**CITY OF EDGERTON
EDGERTON CITY HALL
12 ALBION STREET
EDGERTON, WI**

PLANNING COMMISSION

TO: Edgerton Plan Commission

Engineering Review- Banushi Development

SITE PLAN (ENLARGED)
 SCALE: 1/8" = 1'-0"
 DATE: JANUARY 18, 2021

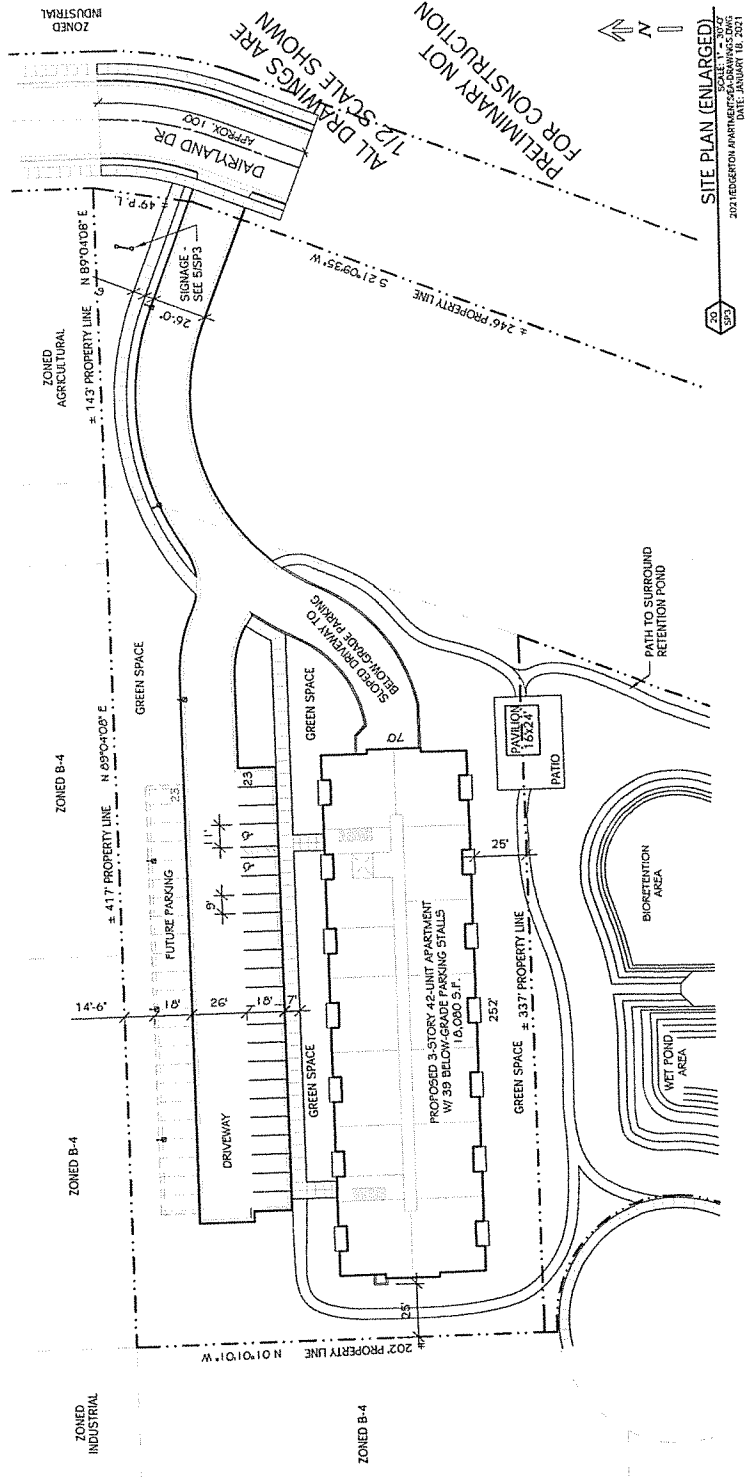
2. Access to the structure will be from a short extension of Dairyland Drive which intersects with Lake Drive Road. The parking lot has been relocated to the north side of the building so the building is now adjacent to the pond.

In addition to the proposed 39 stalls of underground parking, the site plan provides a 23-stall surfacing parking lot for a total of 62 stalls. Twenty three more stalls could be constructed in the parking lot but it appears the developer does not plan to construct those stalls initially. For a conventional development, not a planned development, the ordinance requires 2 stalls per dwelling unit or 84 stalls. There is no on-street parking in this area at this time.

The driveway and parking lot should be curbed. The sidewalk along the parking lot should be raised above the parking lot and it should have accessible ramps.

EDGERTON APARTMENTS
NORTH ELEVATION

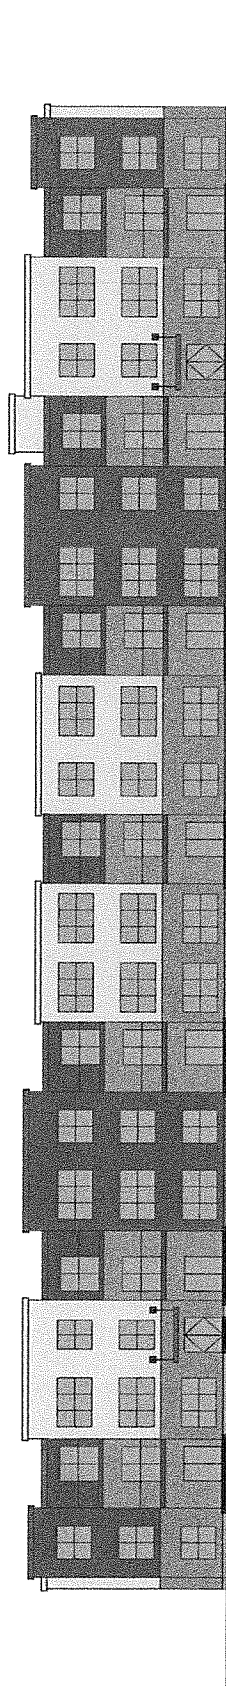
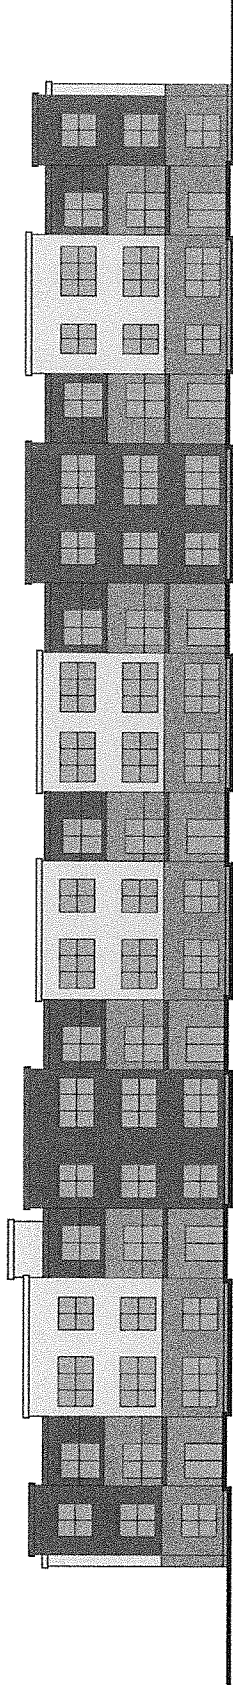
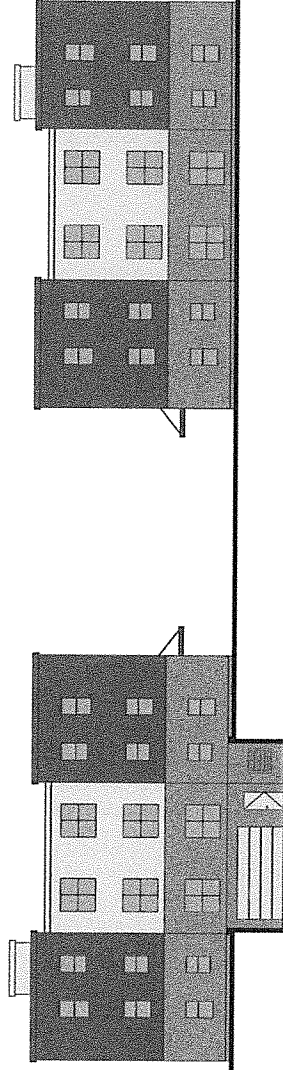
3. The petitioner has modified the roof line and elevations to break up the facade. There are several different building materials and colors proposed for the structure. The building height has been reduced to 34.5' tall by making the roofline flat. The flat roof reduces the mass of the structure although the building is still very large as it is, 252 feet long. In comparison, the three-story portion of Fulton Square condominiums is 210 feet long.

4. The two entrances on the parking lot side of the structure have an awning to identify them on this large façade. More detail should be provided at the entrances. Access through the building to the pond, walking trail, and pavilion on the south side has not been provided. The petitioner should describe where the bank(s) of mail boxes will be and how package delivery will be handled.

12. Please provide a comment and response document with the next submittal.
13. Provide locations, sizes, and types of pipe for sanitary sewer and water services to the building.
14. How is the storm water going to leave the parking lot to the proposed ditch with curb being shown? Will the future parking area be curbed?
15. In all of your elevation views the elevator tower is not shown in the correct location.
